SOUTH CAROLINA BUILDING CODES STATEWIDE MODIFICATIONS INDEX<sup>1</sup>

**SOUTH CAROLINA MODIFICATIONS  
TO THE 2018 EDITION OF THE  
INTERNATIONAL RESIDENTIAL CODE**

FIGURE 307.2  
MINIMUM FIXTURE CLEARANCES

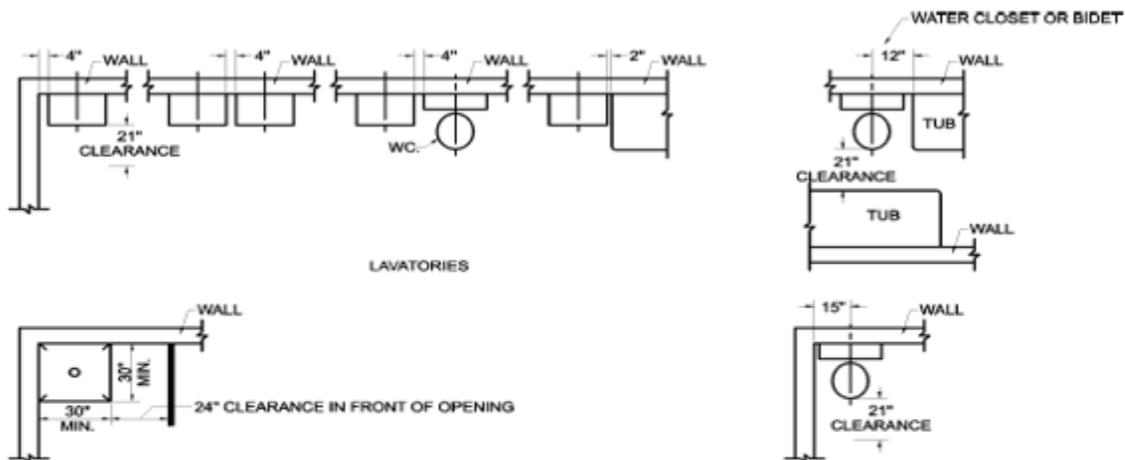
**Modification:** Change the minimum dimension for the side clearance between bathtubs and water closets and bidets from 15 inches to 12 inches.

**Reason:** No valid reason exists to justify a minimum clearance of 15 inches
